CITY PLAN COMMISSION STAFF REPORT

Maple Woods Mixed Use

CD-CPC-2024-00100 Rezoning CD-CPC-2024-00101 Development Plan

Report Date: August 29, 2024 Case Number: CD-CPC-2024-00101 Project: Maple Woods Mixed Use

Date: 8.16.2024 Project #: 1167 Landscape Plan

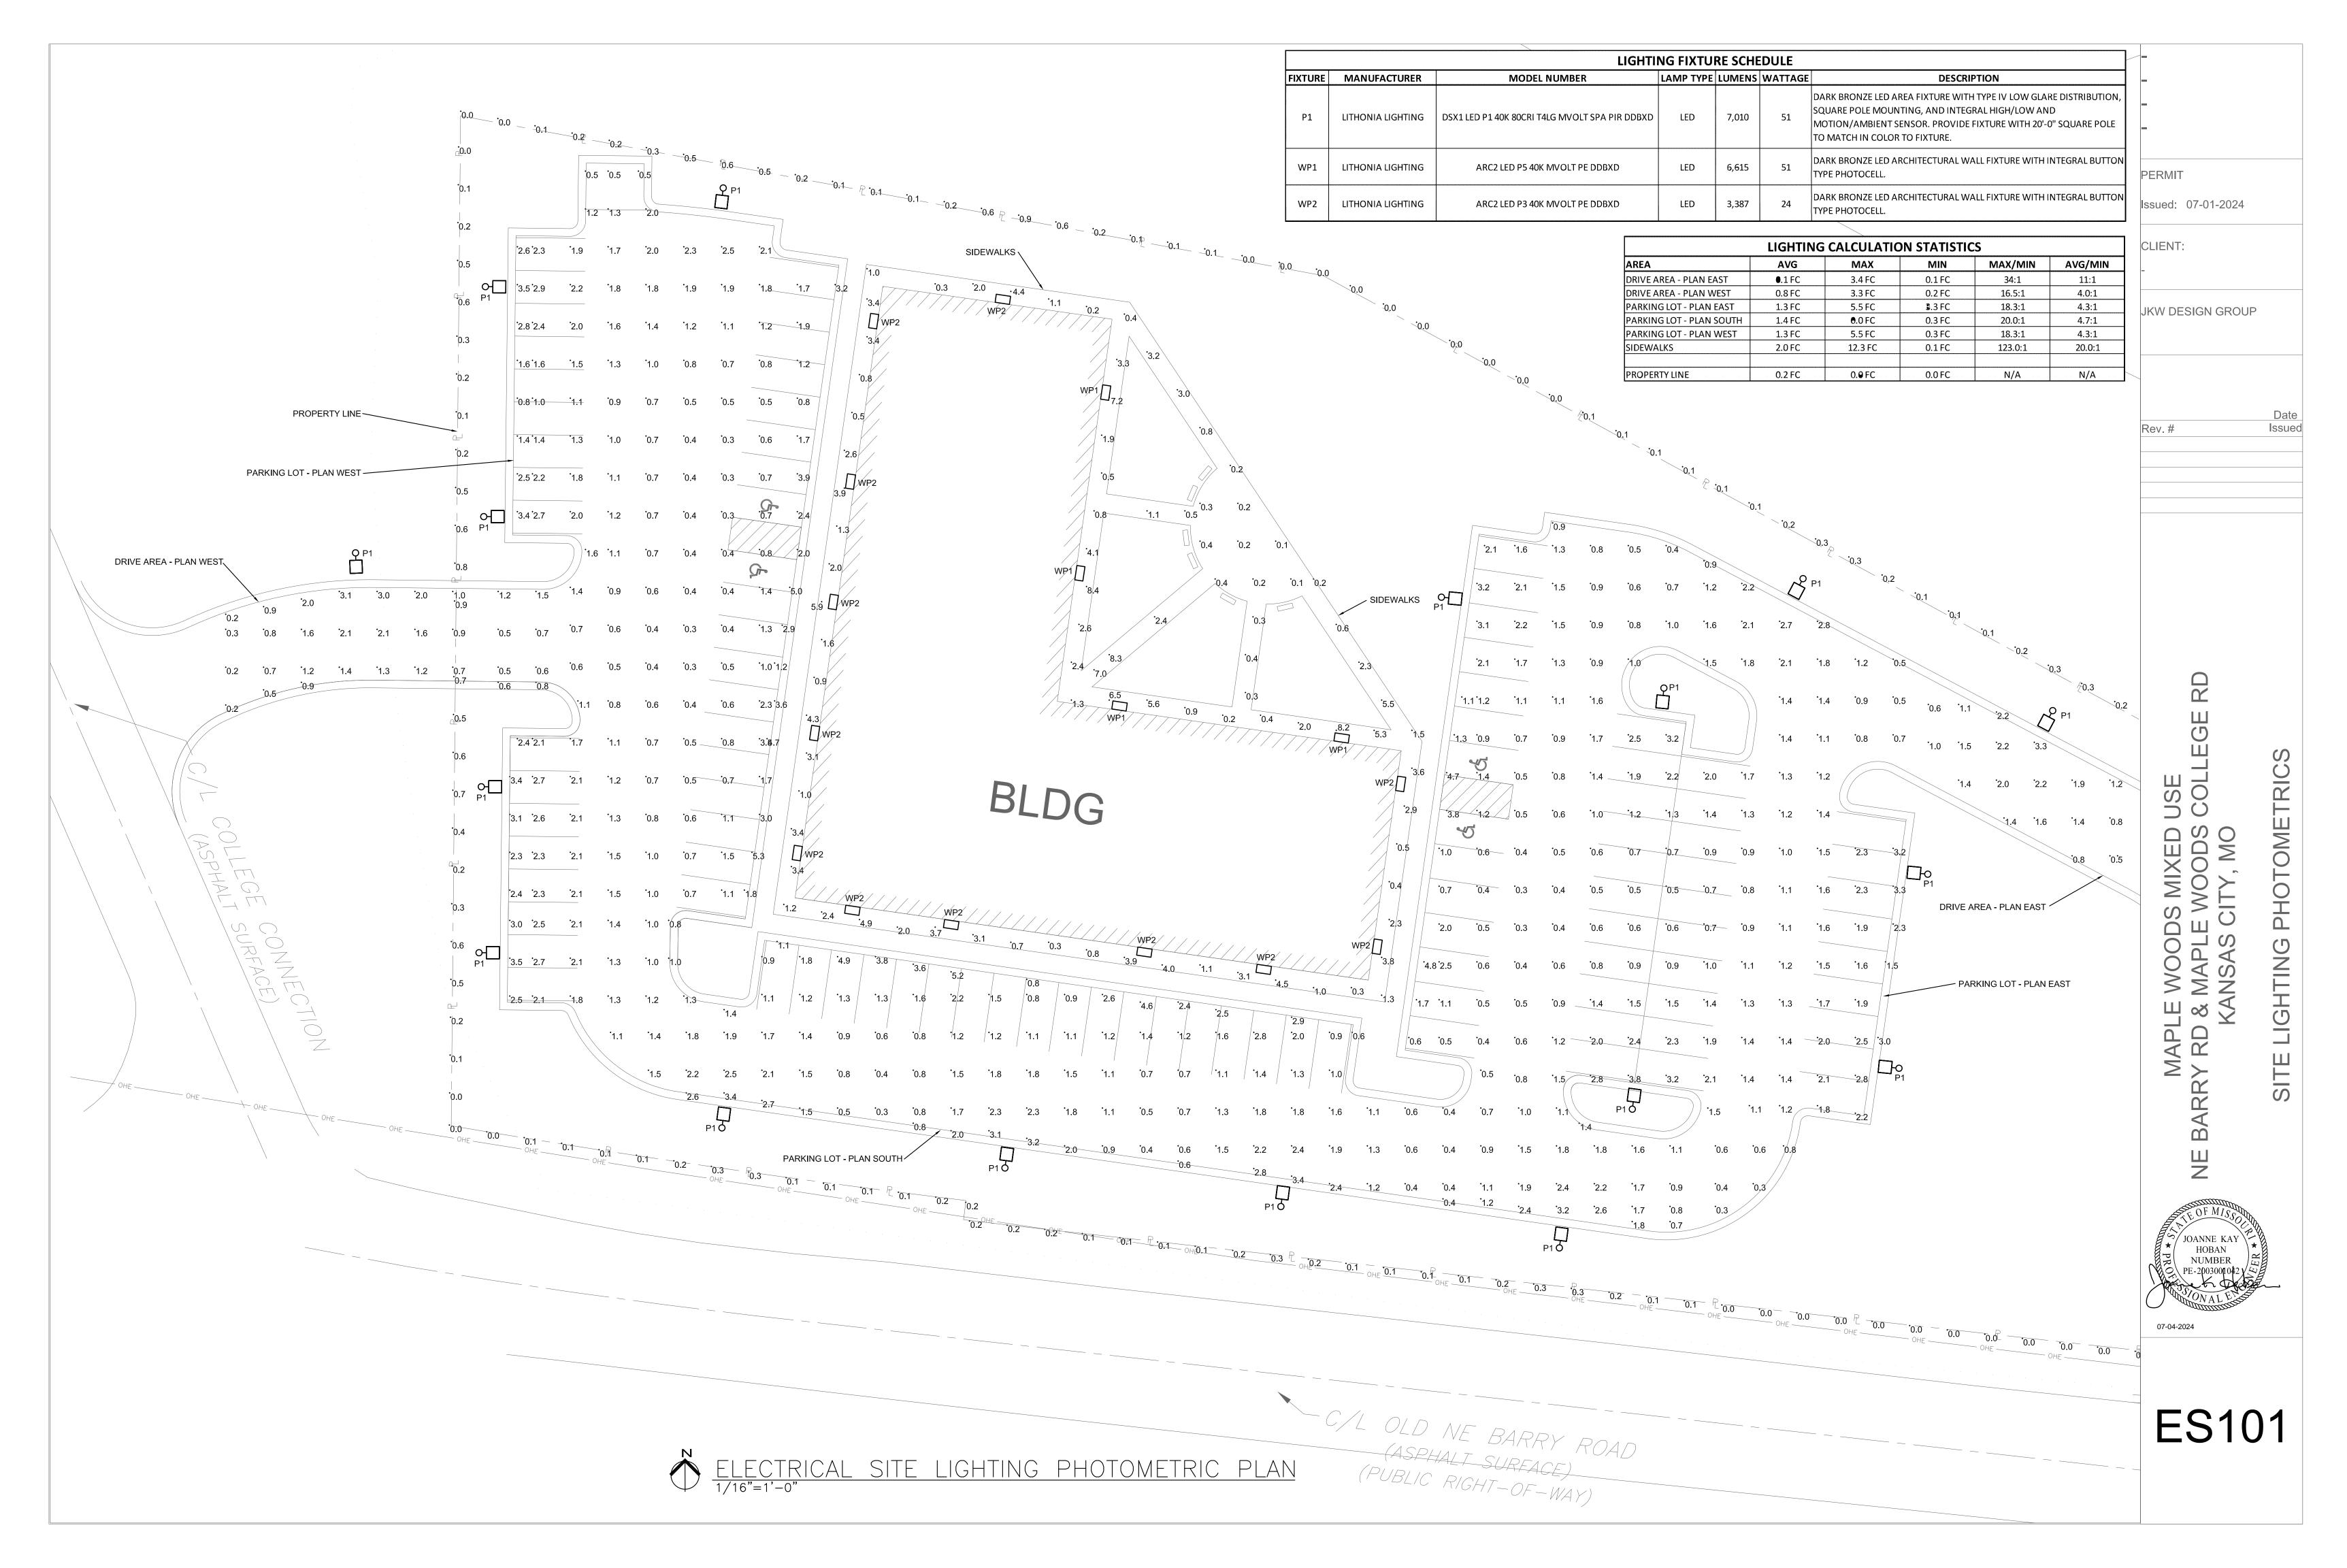
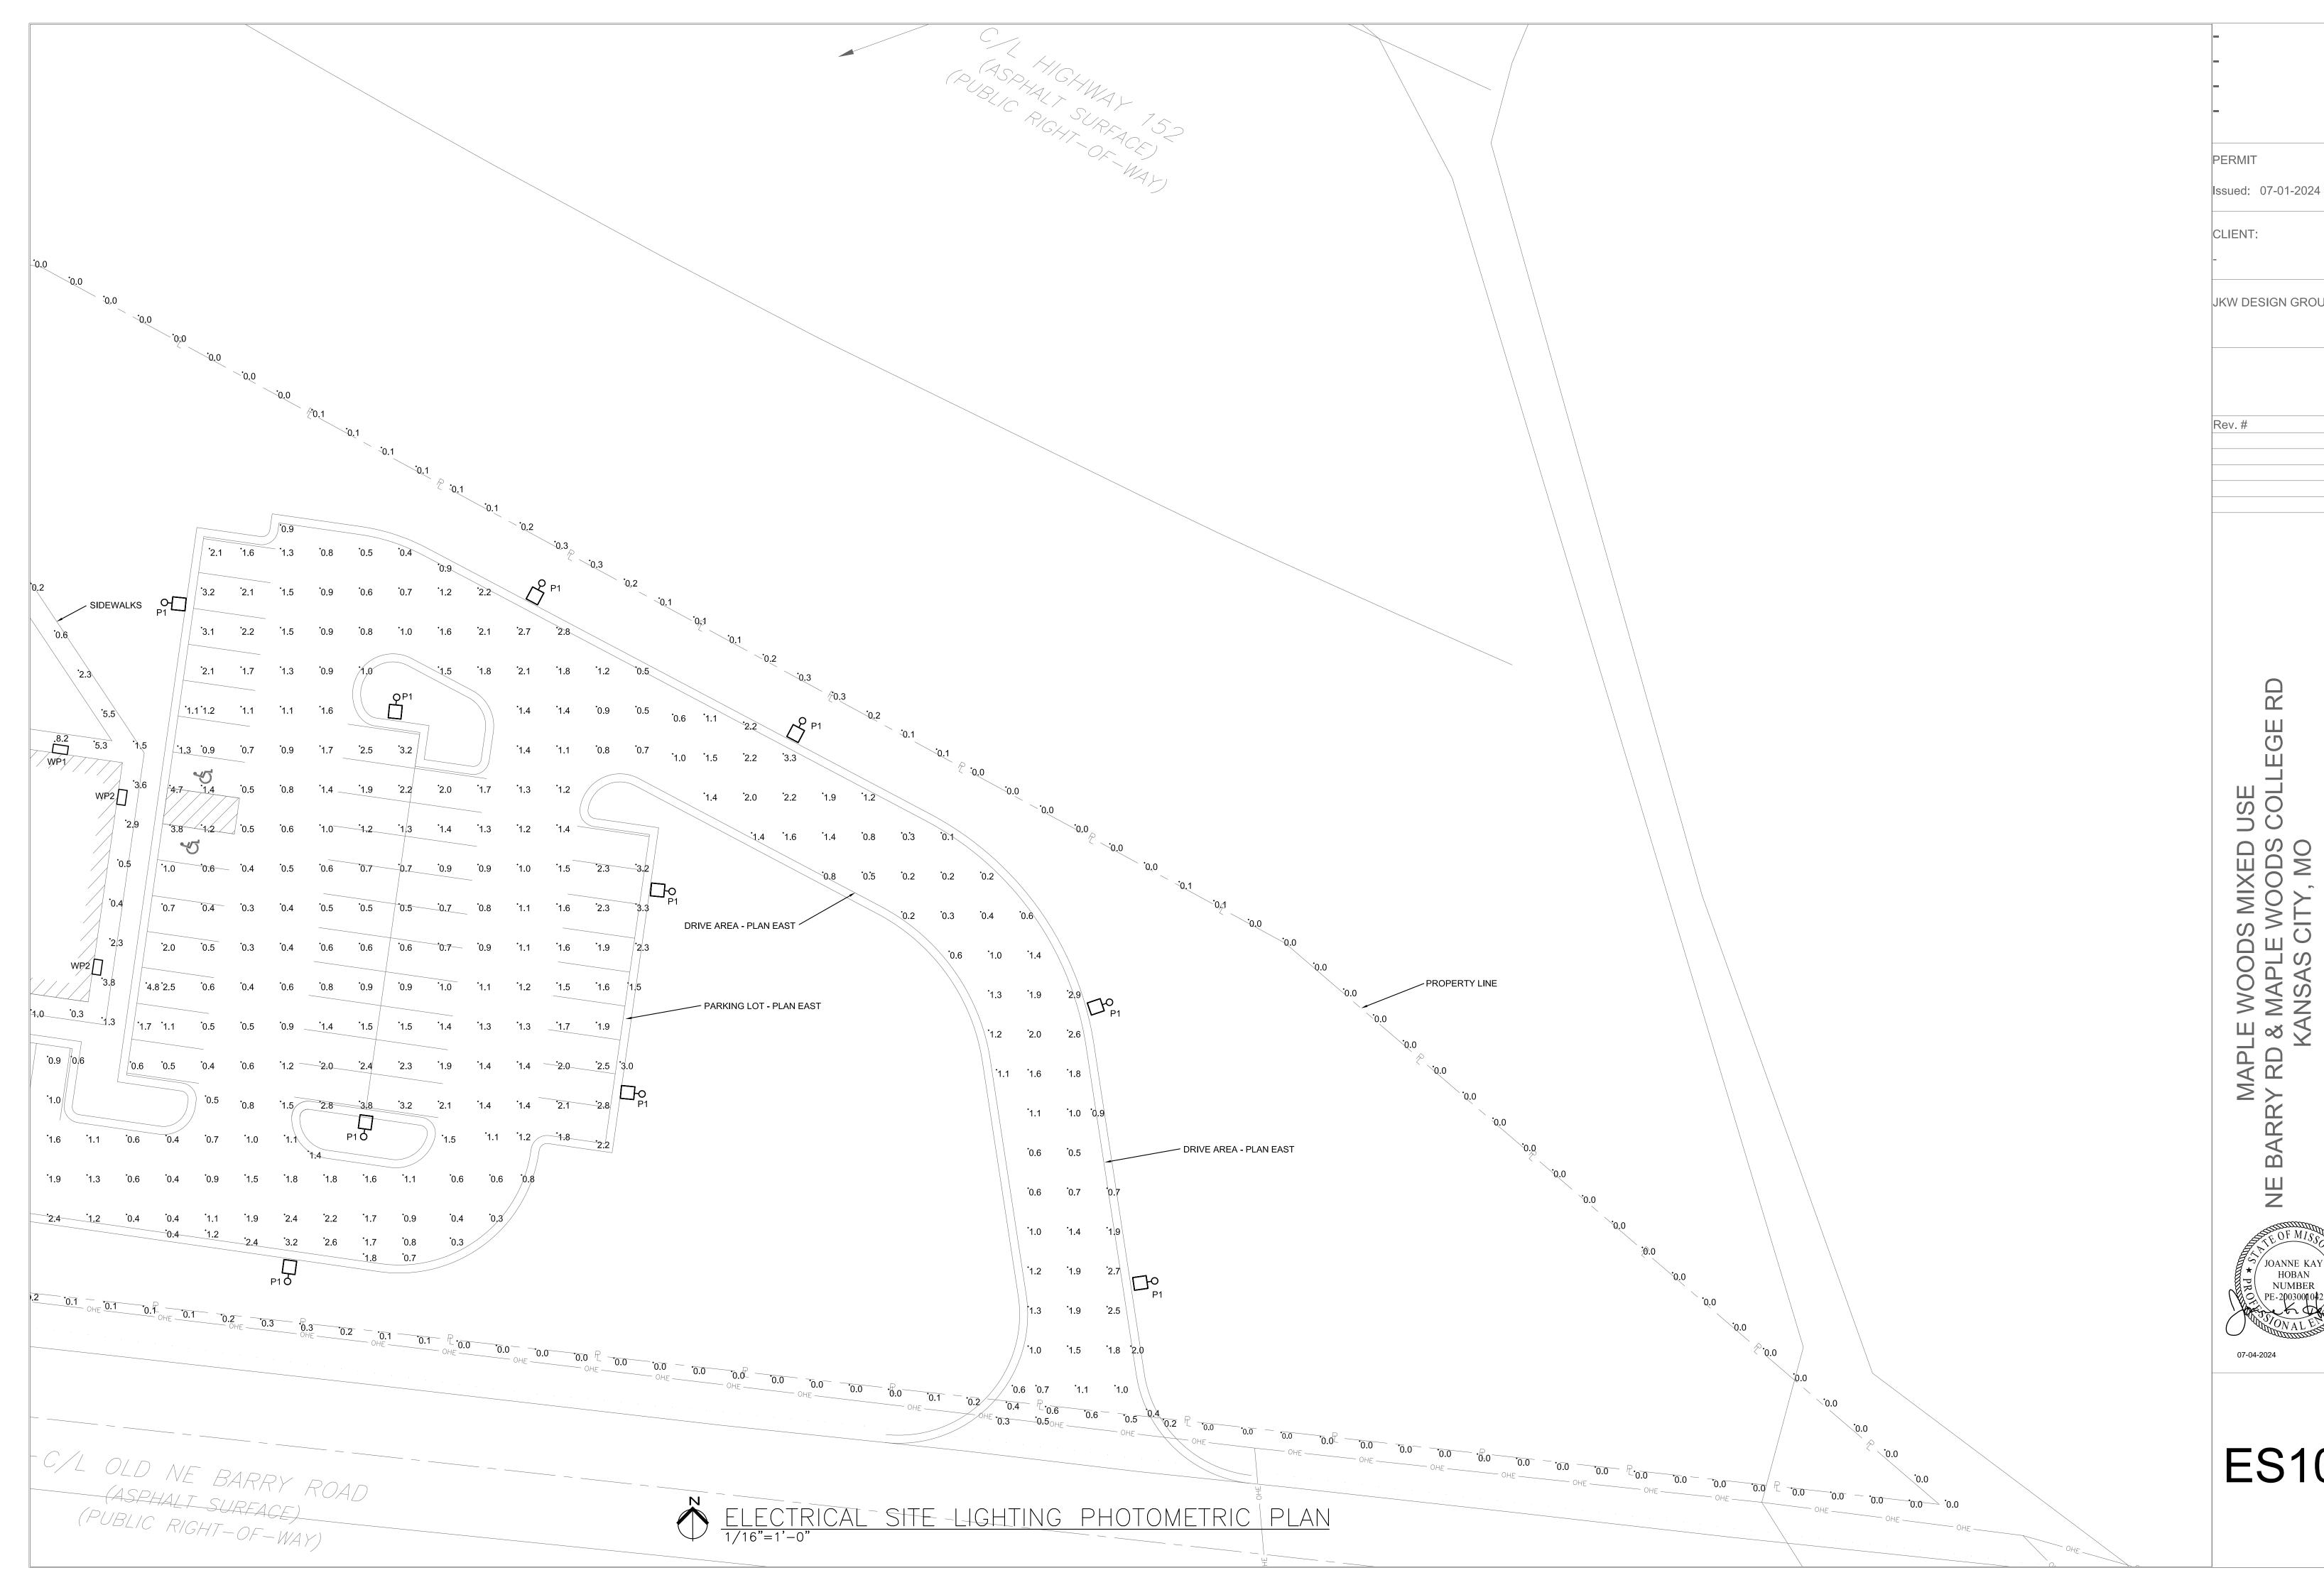
- The current landscape plan does not show the vehicular use area to the south of the building with a continuous line of shrubs to screen from the public right of way. There is a correction to revise the plans prior to ordinance request.
